CONSTRUCTION SUMMARY

Legacy Hill - Trinigroup Development Inc.

LOT / PHASE 32 / 1	REG. PLAN #	HOUSE TYPE Rose 9A Elev 3		
-----------------------	-------------	------------------------------	--	--

LOWER LEVEL
*8'-6" concrete pour

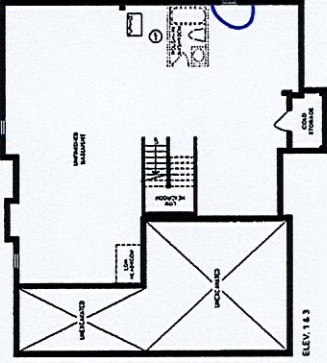
1 - ENLARGED BASEMENT WINDOWS (MAY REQUIRE WINDOW WELLS) - WINDOW IS 30 INCHES X 24 INCHES 21Mar24 Note:	
---	--

Enlarge basement window

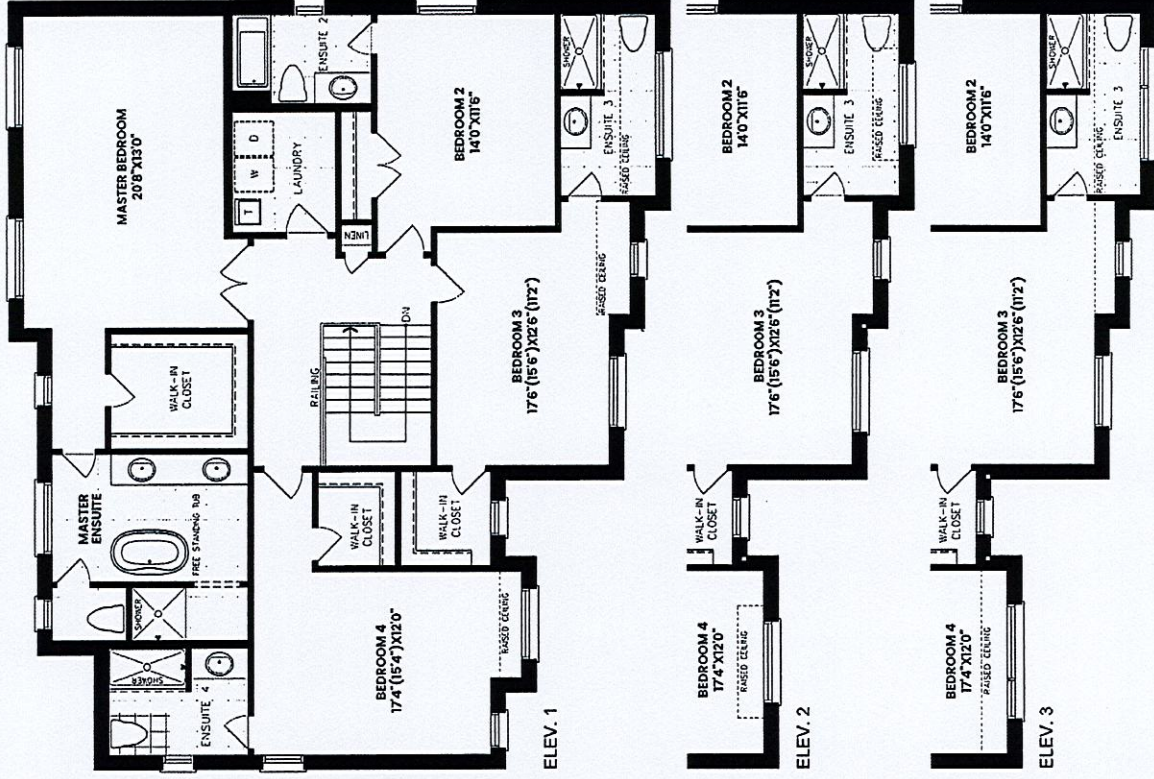
10 foot ceiling height on Main Floor. The Purchaser acknowledges that as a result of the increased ceiling height from the Vendor's standard ceiling height, various modifications to the interior and exterior of the dwelling unit may be made, including bu Worksheet Note:	
(8'6" Pour) If the Purchaser has purchased or been provided with an 8-foot 6-inch basement concrete pour (being an increase from the Vendor's standard basement depth) the depth is measured from the top of footing to the top of foundation wall. The incre Worksheet Note:	
Purchase Price includes a walk up from the basement to the rear of the dwelling unit, and the obligation to construct the house with the walk up is subject to the Vendor's approval, in its sole and unfettered discretion. The Purchaser acknowledges and ag Worksheet Note:

*10'-0" ceiling on First Floor
